**APPLICATION NO** PA/2011/0099

**DEVELOPMENT** Listed building consent to erect a conservatory

**LOCATION** Horkstow Grange, Main Street, Horkstow

**SUMMARY RECOMMENDATION** **Refuse consent**

PA/2011/0098 and 0099 - proposed elevations  
NOT TO SCALE

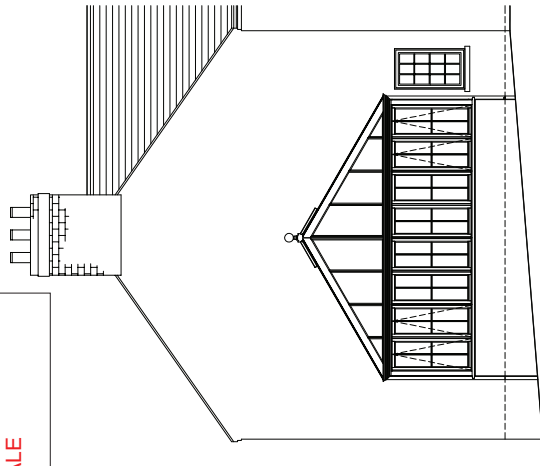
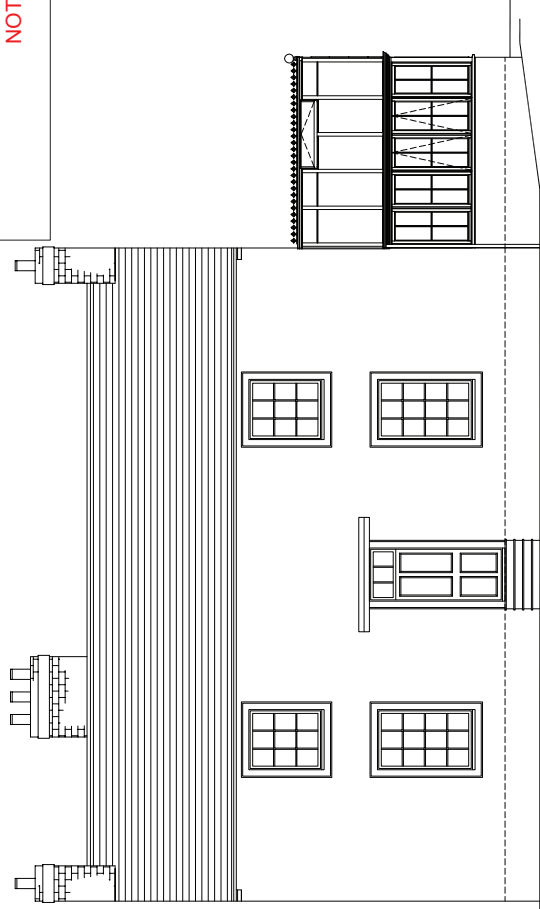
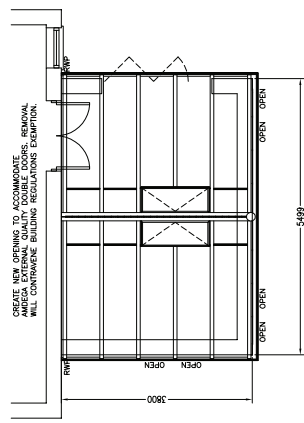
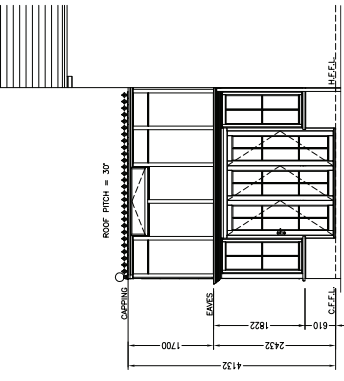
As described above, the proposal is to erect a single-storey conservatory extension on this grade II listed building. The issue is the scale and design of the extension in relation to the character of the listed building. The council's Heritage Team have objected to the proposal on the grounds that the extension will harm the character and appearance of the listed building. Georgian buildings are characterised by their symmetry and regularity of detail. They were designed to have balance and have the building elements in proportion. The existing front elevation of the applicant's dwelling is a classical Georgian style that needs to be conserved. To add an extension to one side of the building will create an imbalance that will detract from the original symmetrical classical design and immediately draw attention away from the balanced front elevation. The erection of a conservatory on the side of the building is an unnecessary alteration that cannot be justified in terms of both local and national policy guidance and is therefore unacceptable. The applicant has been made aware of the issues raised and it has been requested that he consider an alternative location for the conservatory to the rear of the property. However, this is his preferred option.

The existing building is a grade II Georgian detached dwelling which is characterised by its symmetry and regularity of detail. To erect a single-storey conservatory on the side elevation that is visible from the main front elevation is out of keeping with the character and appearance of the dwelling and creates an imbalance in the main front elevation that detracts from the historic character of the building. The proposal does not preserve or enhance the character of the grade II listed building and, as such, is contrary to policies DS1 and HE5 of the North Lincolnshire Local Plan.
